Amendments To The Drawings:

REMARKS/ARGUMENTS

Claims 1-3 are pending in this application.

FIG.1
(RELATED ART)

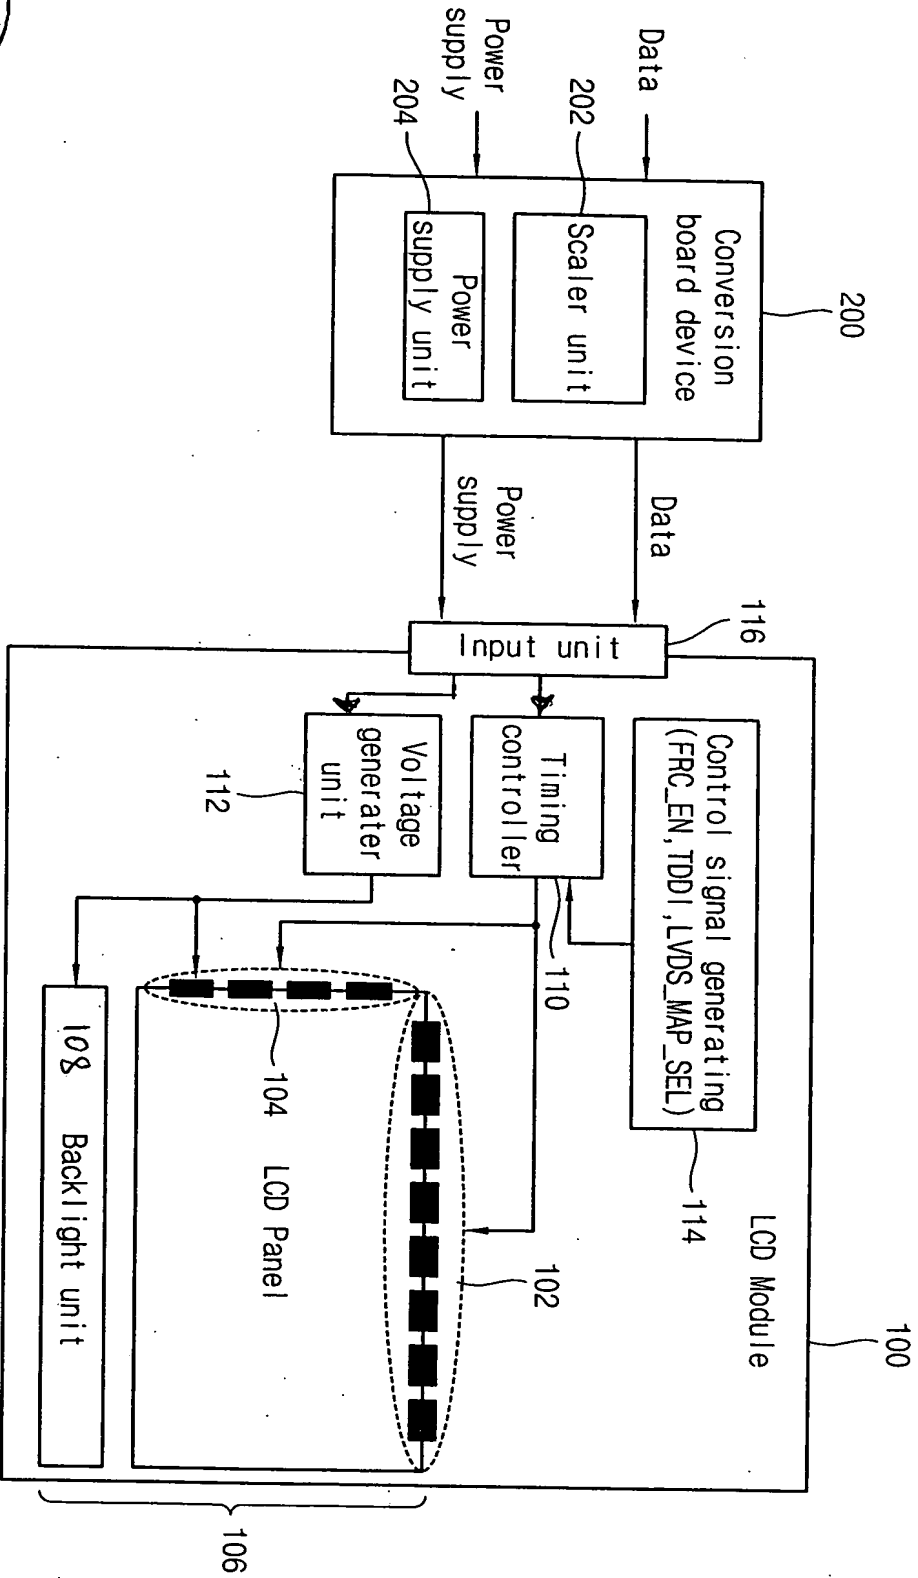
The Examiner noted that a connection is not shown between the "INPUT UNIT" and the "TIMING CONTROLLER" and "VOLTAGE GENERATING UNIT" on both FIG. 1 and FIG. 2. Correction has been made to FIG. 1 and FIG. 2 as shown in the attached drawing sheets.

In addition, reference numeral "108" has also been added to both FIG. 1 and FIG. 2. No new matter has been added to either FIG. 1 or FIG. 2.

FIG.4A
(PRIOR ART)

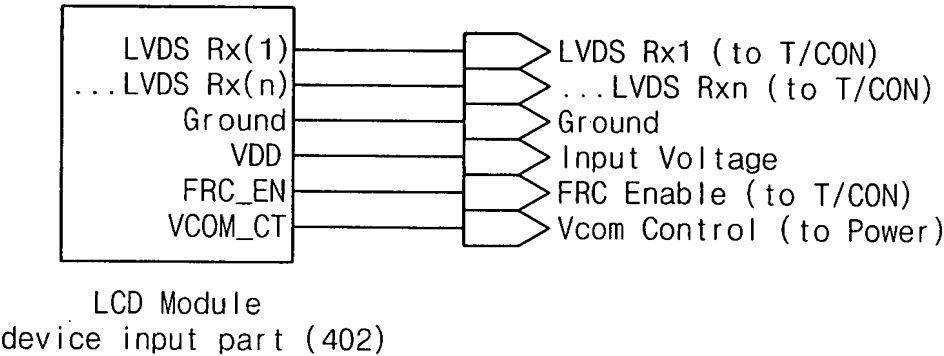
The legend "PRIOR ART" has been added to FIG. 4A and FIG. 4B.
